Proposal for Constellation Re-arrangement in IR HARQ

IEEE C802.16m-08/1333

2008-10-31

Text Proposal to 802.16m SDD

Problem of Current Co-Re Operation

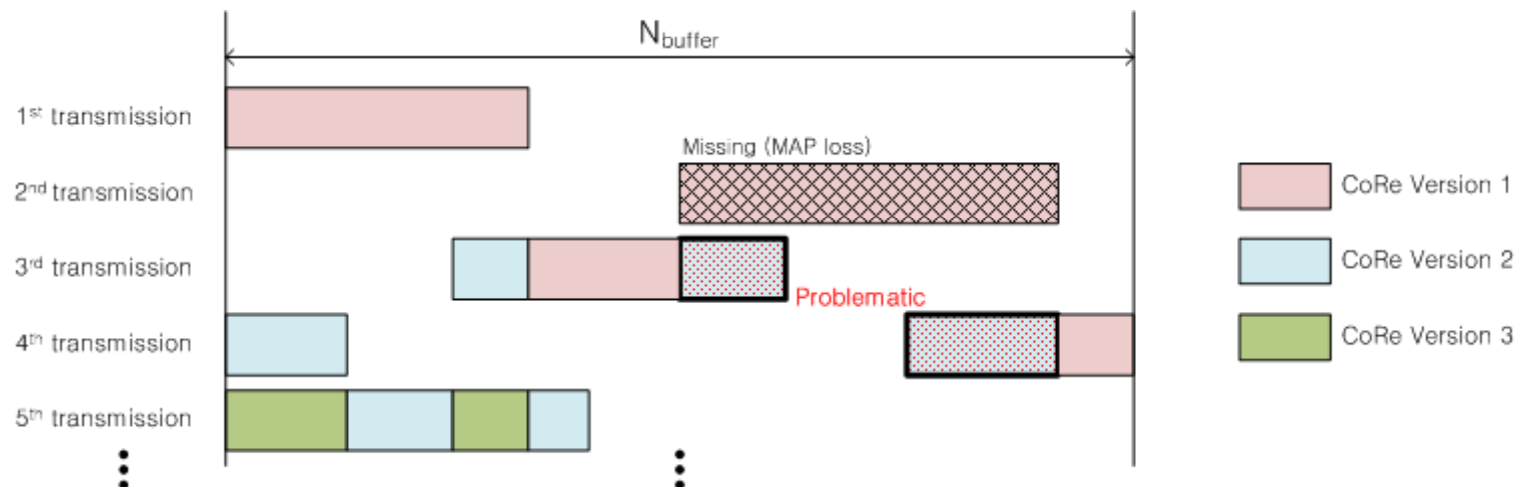
- Current Co-Re operation has a problem in case of IR-HARQ and adaptive HARQ.
 - If the MAP is missing, the MS can't know the CoRe-version for each transmitted bit.
 - In IR and adaptive HARQ operation, this problem is critical.
 - For each transmitted bit, the CoRe-version may be indicated, but the overhead is large.

Proposed Co-Re Operation

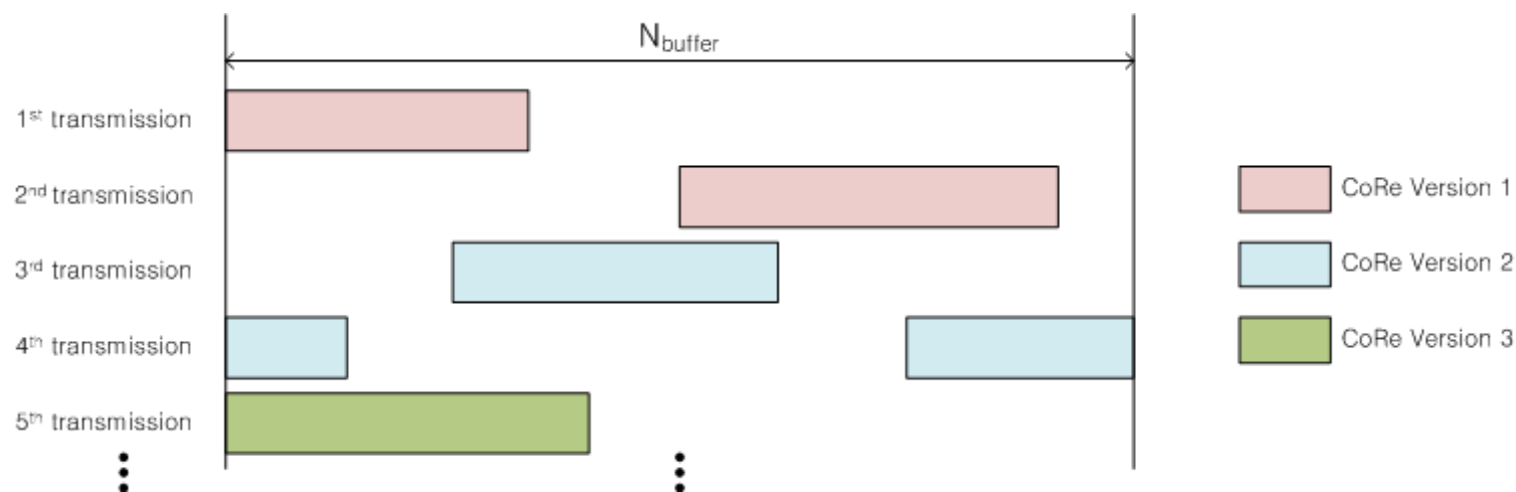
- In the proposed scheme, the CoRe-version is determined by the transmission number of subpacket, not by the transmission number of bit.
 - Robust Co-Re operation in case of MAP loss
 - No additional overhead for CoRe operation

Constellation re-arrangement (Co-Re) is supported in 802.16m. ~~For each transmitted bit,~~ The CoRe-version is selected by the transmission number of ~~this bit~~ subpacket. The specific selection mechanism is FFS.
